HyNet North West

APPLICANT'S COMMENTS ON SUBMISSIONS RECEIVED AT DEADLINE 7

HyNet Carbon Dioxide Pipeline DCO

Document Reference Number D.7.63

<table><tr> <th></th> <th>CO2 Pipeline Constructed First</th> <th>Construction Activities Occur in Parallel</th> <th>Encirc Sidings Constructed First</th> </tr></table>

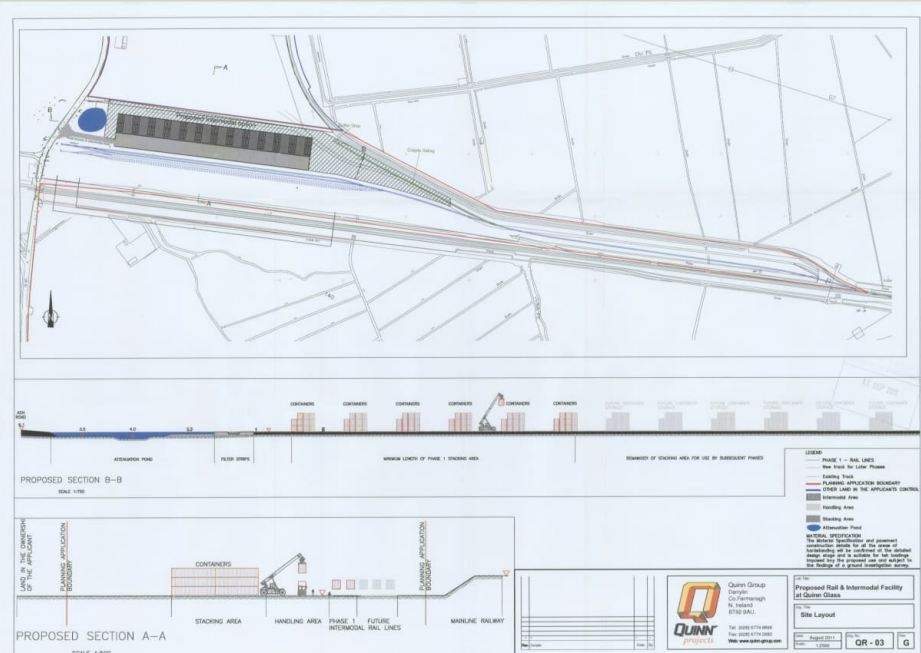
| Reference | Encirc Ref | IP Submission | Applicant's Response | | | | | | | | | | | | |
|-----------------------------|--|--|--|--------------------------------|---|----------------------------------|----------------------------|--|---|--|-----------------------------|--|---|---|--|
| | | <p>these trials in April 2023. A press notice setting out these details is attached at Appendix 5.</p> <p>Pre-application discussion have been held with officers of Cheshire West and Chester in relation to the forthcoming application for the phase 2 intermodal terminal at Encirc. The purpose of these discussions was to scope the planning application and the potential for EIA to be required and the likely scope of such EIA. Commencement of the development of Encirc's product export intermodal facility is scheduled for 2025.</p> | | | | | | | | | | | | | |
| 2.4.5 | 2.11 | <p>Encirc's consultants (Lichfields and Eversheds) met with representatives of the applicant on 10 August 2023 to allow the applicant to explain the engineering requirements for passing the pipeline beneath the rail lines at Land Plots 1-19 to 1-24. It was explained that:</p> <p><i>1 directional drilling of a pipeline beneath all rail lines was technically possible, but without Network Rail approving that solution, the applicant was not able to commit to it as a construction methodology; and</i></p> <p><i>2 Without Network Rail 's approval of directional drilling, the DCO would need to include for the construction of the pipeline beneath the rail lines to incorporate a vertical shaft between the rail lines to accommodate boring infrastructure in both directions. This shaft would need to be located on plot 1-22 and involve the necessary acquisition of rights over plot 1-22 requiring access from plots 1-06a to 1-06 and from plots 1-02 to plots 1-06 and thence to plot 1-22. This would require the DCO to confirm rights to the applicant over land where Encirc proposes to build new rail lines and the phase 2 intermodal facility.</i></p> | <p>The Applicant notes this response from Encirc Limited, which highlights the proactive engagement between the parties to secure a private agreement. The Applicant will seek to continue this engagement in the spirit of flexibility, openness and willingness to resolve Encirc's concerns and objection with the aim to ensure both Parties' development plans can co-exist.</p> <p>The Applicant notes this response from Encirc Limited and would like to refer to its response, as stated in the Applicants Final Position Statement (document reference: D.7.65) submitted at Deadline 8.</p> <p>The Applicant hopes that Encirc Limited remains open to resolve the outstanding points via a mutually acceptable private agreement.</p> | | | | | | | | | | | | |
| 2.4.6 | 2.12 – 2.13 | <p>A meeting was held between the applicant and Encirc on 24th August 2023, to further discuss the implications of the above scenarios. This introduced the potential timings of the relative works by Encirc and the applicant. The table below was presented for discussion. It is a helpful summary of three timeline scenarios and the implications of not undertaking a single directional drilled construction methodology beneath the rail lines.</p>

<p>In summary, a single trenchless crossing is technically achievable. If this method is followed, only access to plot 1-22 is required for monitoring purposes and a permanent right of access to plot 1-22 can be provided by Encirc. If plot 1-06 is required for access to 1- 22 for monitoring purposes, then it must be varied so that it does not interfere with the planned intermodal facility. A trenchless crossing also means that permanent rights to Plot 1-21 would not be needed. Requesting</p> | | CO2 Pipeline Constructed First | Construction Activities Occur in Parallel | Encirc Sidings Constructed First | Single Trenchless Crossing | Possible – confirmation from NR required in Detailed Engineering | Future Agreement needed, triggered by both parties notifying the other of their intent to carry out works | Possible and likely construction technique | Intermediate Shaft Required | Possible – confirmation from NR required in Detailed Engineering | Future Agreement needed, triggered by both parties notifying the other of their intent to carry out works | Unlikely to be possible (not enough space / disruption to Encirc's new development) | |
| | CO2 Pipeline Constructed First | Construction Activities Occur in Parallel | Encirc Sidings Constructed First | | | | | | | | | | | | |
| Single Trenchless Crossing | Possible – confirmation from NR required in Detailed Engineering | Future Agreement needed, triggered by both parties notifying the other of their intent to carry out works | Possible and likely construction technique | | | | | | | | | | | | |
| Intermediate Shaft Required | Possible – confirmation from NR required in Detailed Engineering | Future Agreement needed, triggered by both parties notifying the other of their intent to carry out works | Unlikely to be possible (not enough space / disruption to Encirc's new development) | | | | | | | | | | | | |

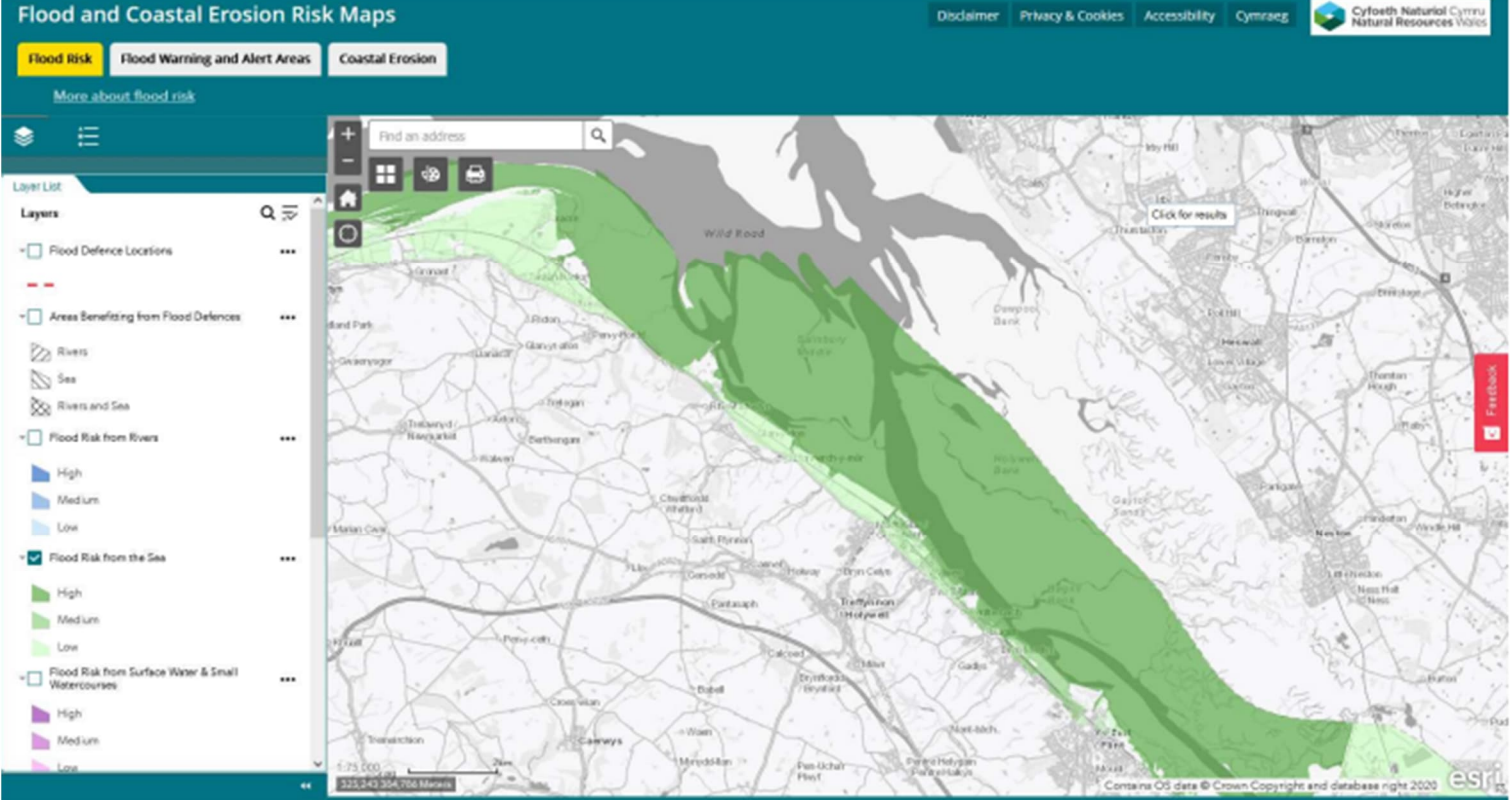
| Reference | Nicky Crosby Reference | IP Submission | Applicant's Response |
|-----------|------------------------|--|----------------------|
| | | <p data-bbox="477 327 1887 1073">  </p> <p data-bbox="477 1094 1887 1167">substantially agrees that at Point of Ayr and along the pipeline route, there is High flood risk from the sea. High means that “each year, this area has a chance of flooding of greater than 1 in 30 (3.3%)”</p> <p data-bbox="477 1178 1887 1461">The maps show that substantial sections of the pipeline, as well as Aston Hill BVS and the Point of Ayr terminal, will be below annual flood levels by 2050. Aston Hill BVS (Diagram EN070007-D.2.8-EL-Sheet 3, D.2.8 updated Mar 23), does not appear to be mentioned in the flood risk assessment with the (D.6.3.18.4). The Point of Ayr terminal has been scoped out of this assessment, but is presumably essential for pipeline operation. Although the applicant has quoted climate related sea level rises in the Flood Risk Assessment, this does not appear to have been discussed in meetings with the Environment Agency or Natural Resource Wales. The applicant has not indicated impact or mitigation. What arrangements has the applicant made for maintenance and security of the pipeline when under water?</p> | |
